Re: **Glen Burnie Heights**  
**Block PP, Lots 38-39**  
**Variance Application**

SHEET 1 OF 1  
**VARIANCE PLAN**  
**GLEN BURNIE HEIGHTS**  
**Section PP, Lots 38-39**  
 SUBDIVISION #S2023-\_\_\_\_ PROJECT #P2023-00-\_\_\_\_-00NM  
 TAX MAP 09 GRID 23 PARCEL 146 TAX ACCOUNT #03-362-07827800  
 307 BROAD AVENUE, GLEN BURNIE,  
 3RD ASSESSMENT DISTRICT, ANNE ARUNDEL COUNTY, MARYLAND 21061  
 SCALE: 1" = 20' DATE: JULY, 2024

NUMBER: 2024-0125-V

## CONFIRMATION OF PRE-FILE MEETING

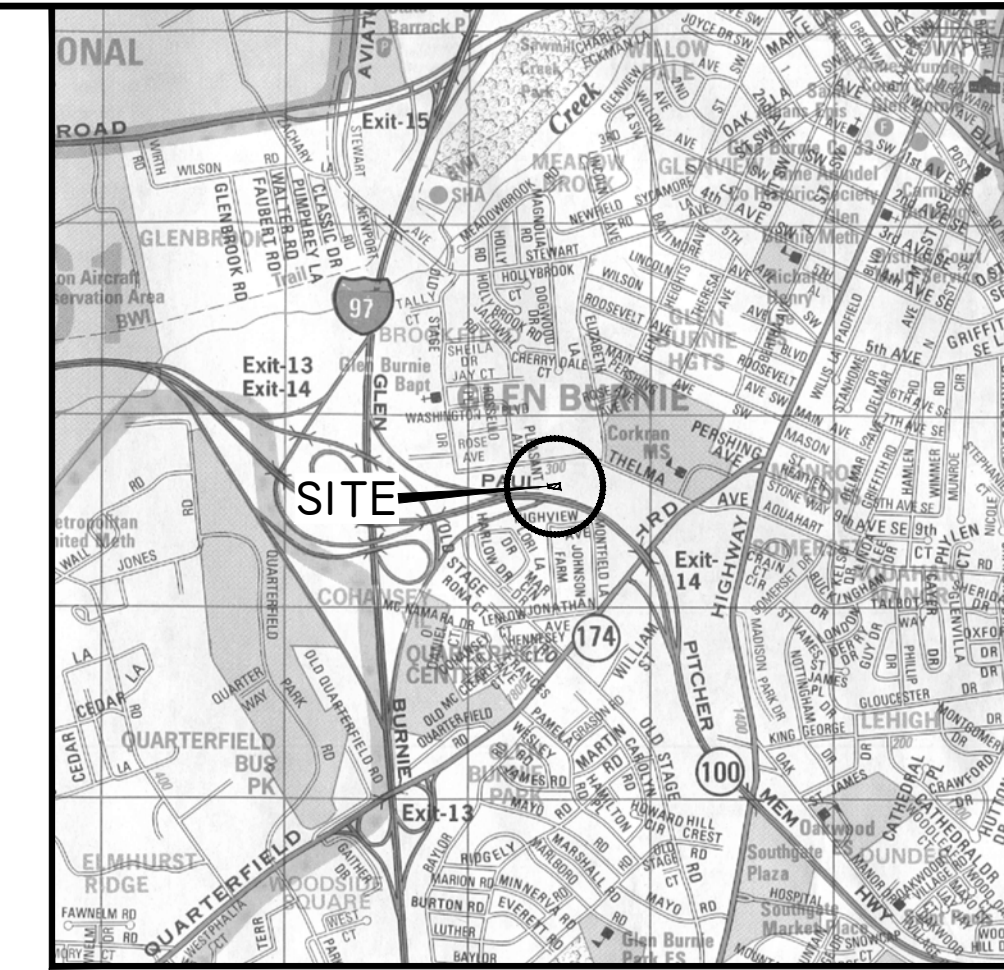
1. This reviewer is not clear about what type of SWM practice (s) are proposed. Per 6.1.4 (G) of the County Stormwater Practices and Procedures manual, SWM facilities shall not be located in areas that are off-limits to development, e.g., natural resources including steep slopes and buffers.

2. Identify site outfall to review the site plan and provide feedback regarding potential impact.
3. A soil boring is required per practice. The suitability and siting of proposed SWM practices should be reviewed. Soil boring information including verification of the suitability of in-situ soils for infiltration shall be submitted. Describe the site's hydrologic, and topographic characteristics and provide a recommendation on the feasibility of various BMPs.

4. All stormwater conveyance systems shall be designed so that no building or habitable structure, either proposed or existing, is flooded or has water impounded against it during the 100-year storm event.

5. Microscale stormwater facility(ies) design should incorporate safe conveyance for overflow discharges from 2, 10, 100-yr 24-hr storm events; plans should show overland relief paths for these storm events and ensure that no structures, or properties are negatively impacted or have water impounded against during these storm events.

6. The County Stormwater manual requires that Infiltration devices uphill from buildings and structures with basements shall be located a minimum of 20 feet from the structure, or the intersection of the structure foundation footing with the phreatic line from the overflow depth of the device, whichever is greater. Please clarify how this requirement is met.

7. Infiltration/filtration devices, including individual lot devices, shall be located a minimum of 10 feet horizontally from any public sanitary sewer or house connection, or property line.

8. The site to ensure that any existing downstream flooding including nuisance flooding issues will be exacerbated by the proposed development.
9. Design professionals should review site runoff and potential (negative, adverse) impacts to neighboring properties, due to changed grades/elevation on a proposed project.
